Item No. 10.2.1
Regional Centre Community Council
January 27, 2021

SUBJECT: **Case 23178: Appeal of Site Plan Approval – 6399, 6395, & 6389 North Street, Halifax**

① West-Seaforth St.
 1/8" = 1'-0"

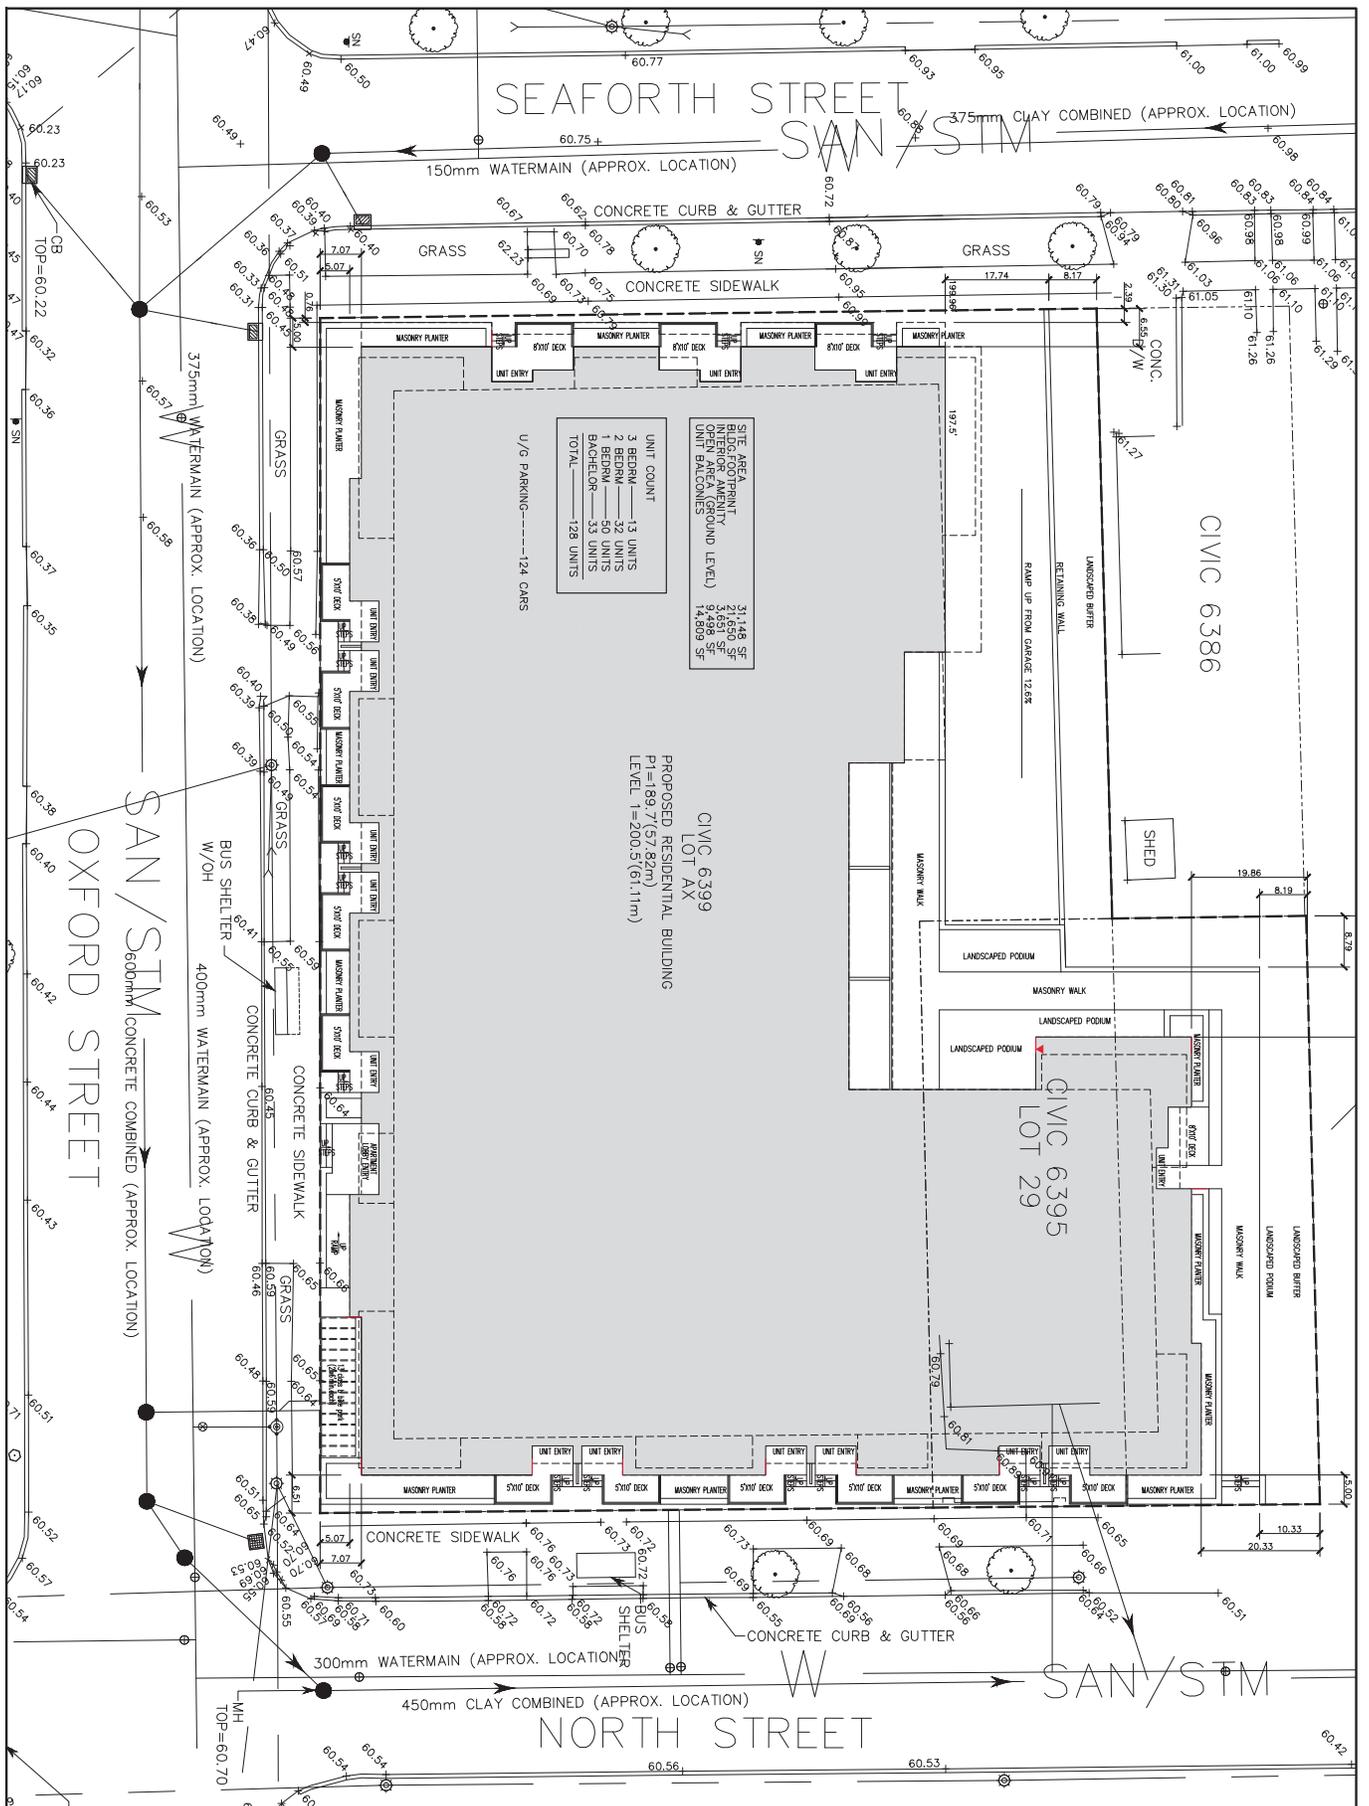
My concern is with the parking exiting this complex onto Seaforth Street as I feel this will overwhelm residential traffic as well as limit available on-street parking, which is already an issue with the frequent congregation of the church (St. Theresa's Catholic Rectory).

I suggest that the parking exiting this complex be placed on Oxford or North Street for ease of traffic concerns.

<p>Concern is with the parking exiting this complex onto Seaforth Street it will overwhelm residential traffic as well as limit available on-street parking, which is already an issue with the frequent congregation of the church (St. Theresa’s Catholic Rectory). Suggestion that the parking exiting this complex be placed on Oxford or North Street for ease of traffic concerns.</p>	<p>Part VI, Chapter 4 regulates building and site design related to parking and vehicle access. It does not regulate the location of the driveway on the lot. This is regulated by By-law S-300, Respecting Streets. This bylaw restricts driveways within 100 metres of a signalized intersection, and stipulates that a driveway shall be located on the street that carries the lesser amount of daily traffic. It is outside the scope of the land use bylaw and the site plan approval process and is outside of the scope of the consideration of the appeal.</p>
